## Addendum 2

Tender	Kalbarri Disaster Recovery Works AGRN965	RFT No.	RFT08/2023
From	Antoinette Krause	Contact	antoinette.krause@ghd.com
Addendum	Addendum 2

Figure 1

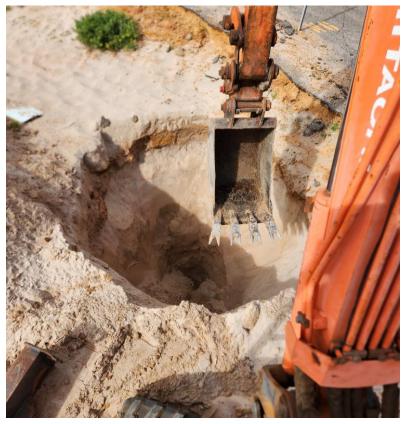
2.	Chinaman's Beach geotechnical investigation	A geotechnical investigation was not undertaken, however, a number of test pits were excavated to determine estimated rock levels for the proposed limestone block retaining wall. The depths were measure by HTD surveyors. The data has been attached in Appendix A.

Chinaman's Beach - Test Pit – central location along work site
